24 November 2021

RE: AMENDMENT REPORT FOR SSD-11869481, UPGRADES TO NORTH SYDNEY PUBLIC SCHOOL

2. Description of Proposed Amendments

Figure 2: Amended Bay Road entry (Source: Fulton Trotter)

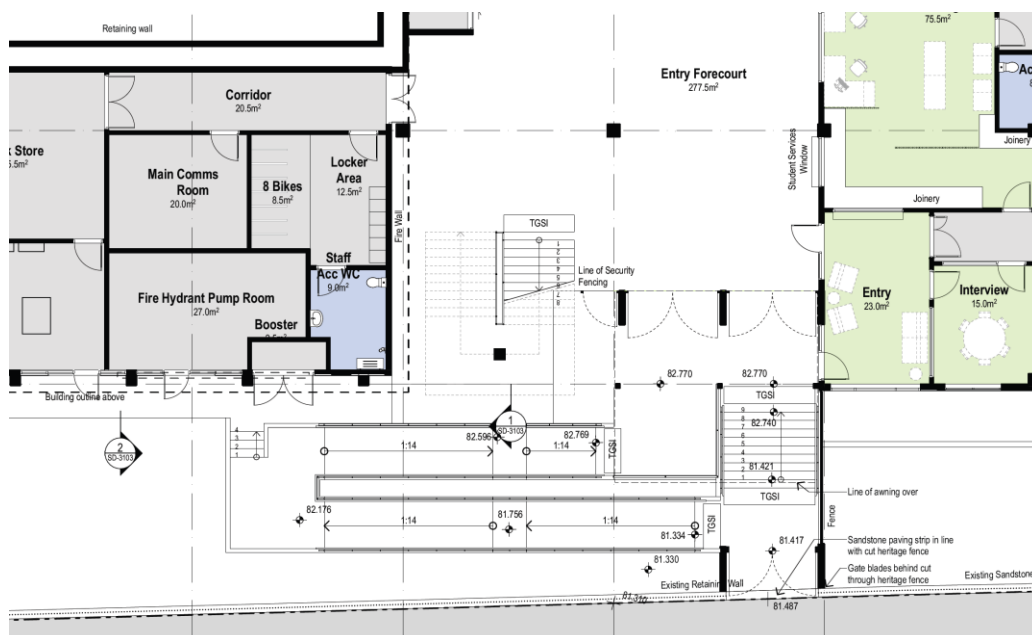
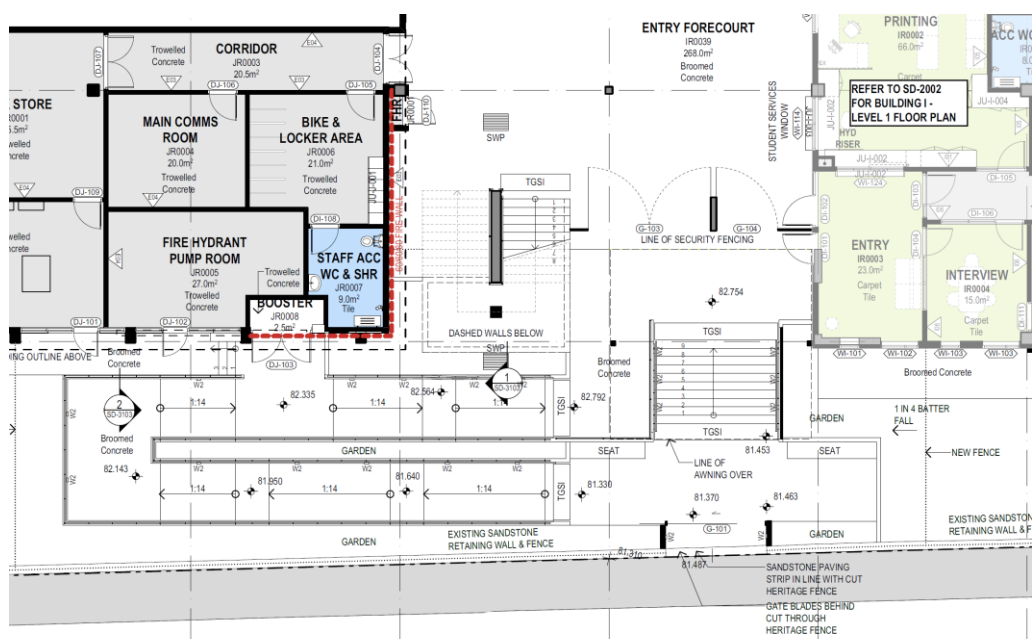
- Configuring the entry stair and ramp to the site from Bay Road centrally under the awning roof;
- Replacing the swing gates with sliding gates;
- Widening the stairs from 3.5 metres to 4.5 metres;
- Widening the ramps from 1.75 metres to 2.1 metres; and
- Configuring the entry design to create an increased forecourt area at street level at the base of the stairs.

Figure 6: Extract of amended Building J level 1 floor plan, showing recess of the built form (Source: Fulton Trotter)

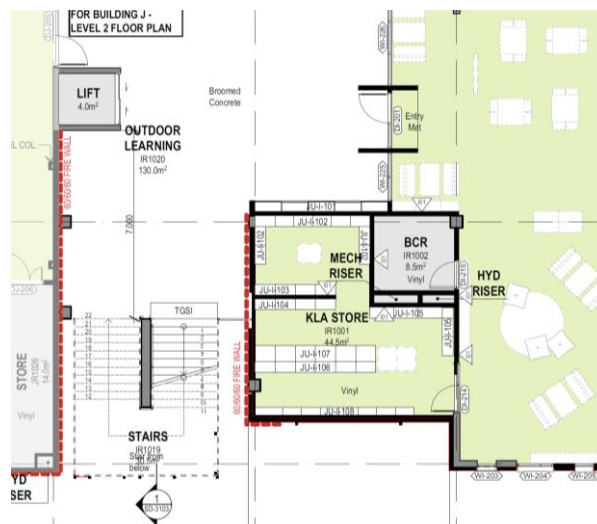
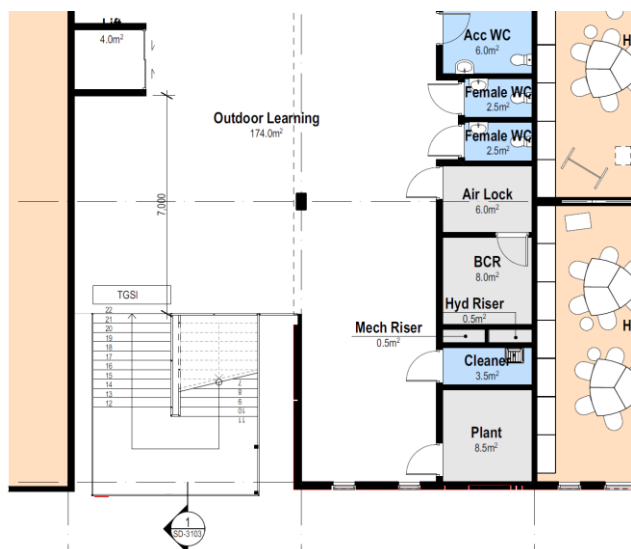
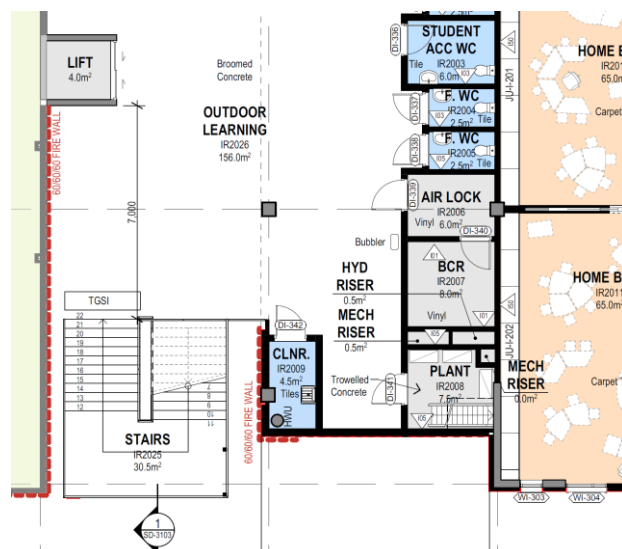
- Transition of the glassfibre reinforced concrete (GRC) panelling from large format panels to smaller-scale panels. Refer to Figures 3 and 4.
- The product chosen provides texture finishes with the panelised system. Refer to Figure 3 and 4;
- The depth of the placement of windows within the façade has increased, emphasising the 'punched' nature of the windows and a framing element added to tie the vertical panels of the window in a similar structure of the detailing of the existing brick buildings on the site. Refer to Figure 3 and 4; and
- Alteration to the planning of the buildings above the entry and entry awning to allow the building form to be recessed at this point. Refer to Figures 5- 8.

Figure 10: Amended PV layout on the roof of Building J (Source: Fulton Trotter)

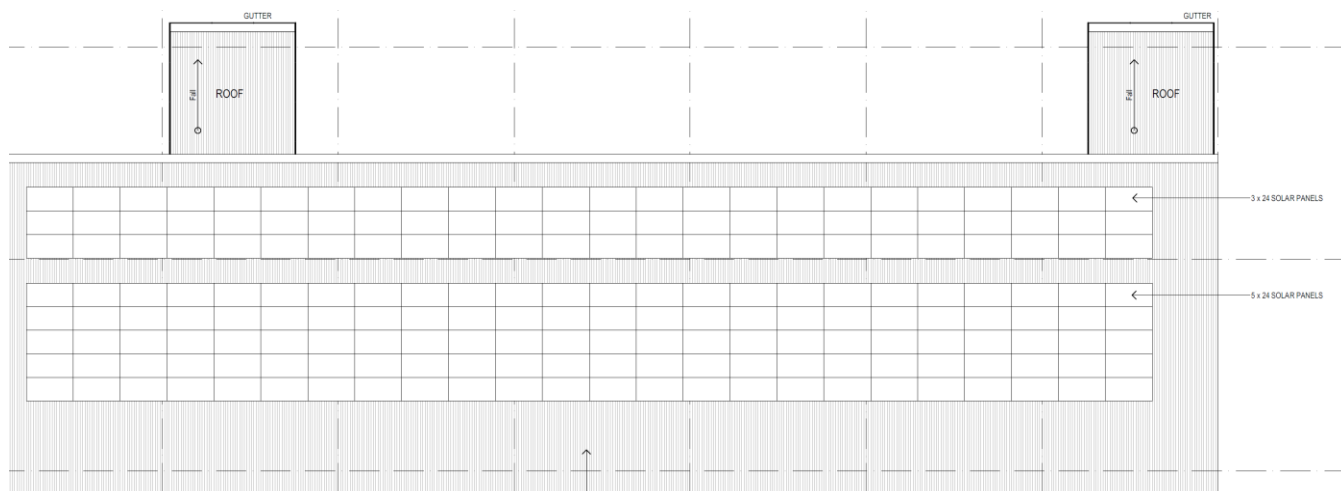
As illustrated on the amended Architectural Plans (Appendix 2), the PV layout has been amended to run north to south vertically, rather than east to west horizontally, as previously proposed. As a result of the amended layout, four additional panels are proposed. Refer to the following figures.

Figure 12: Extract of the amended elevation entry signage to Building J (Source: Fulton Trotter)

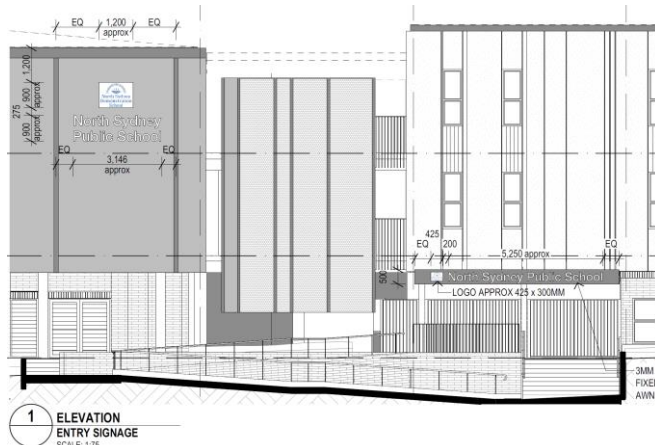
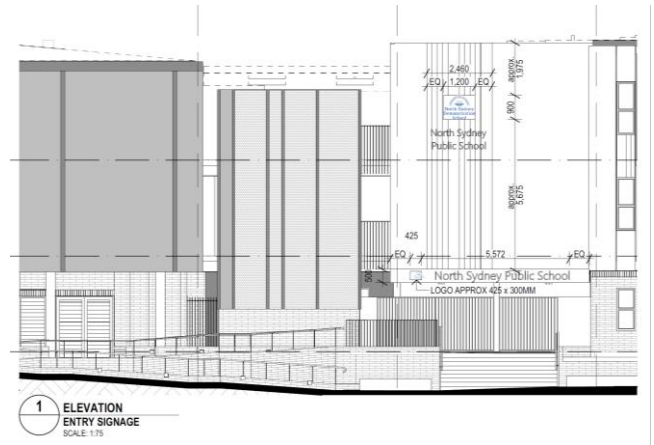
The school identification sign which contains the school logo and words *North Sydney Demonstration School* has been relocated from the southern façade of Building I, to proposed recessed portion of Building J above the entry forecourt. Refer to the following images.

Figure 14: Extract of amended east elevation of Building I (Source: Fulton Trotter)

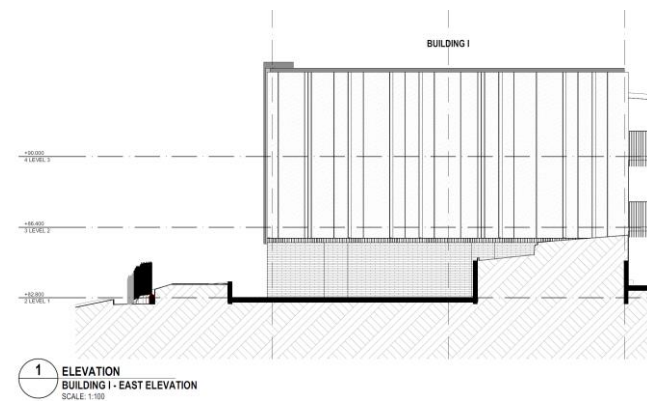
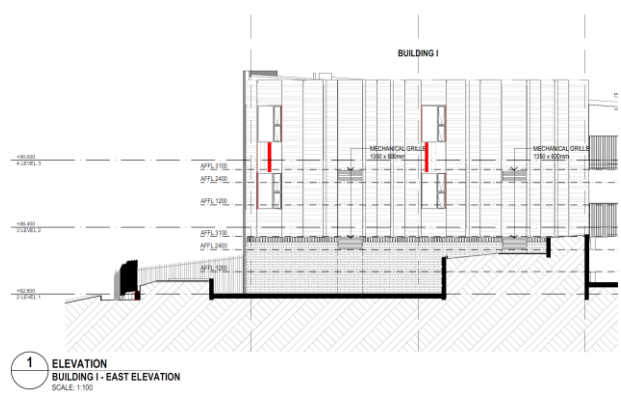
In response to the SDRP feedback, Fulton Trotter has added windows and textured detail to the eastern façade of Building I, see below comparison images.
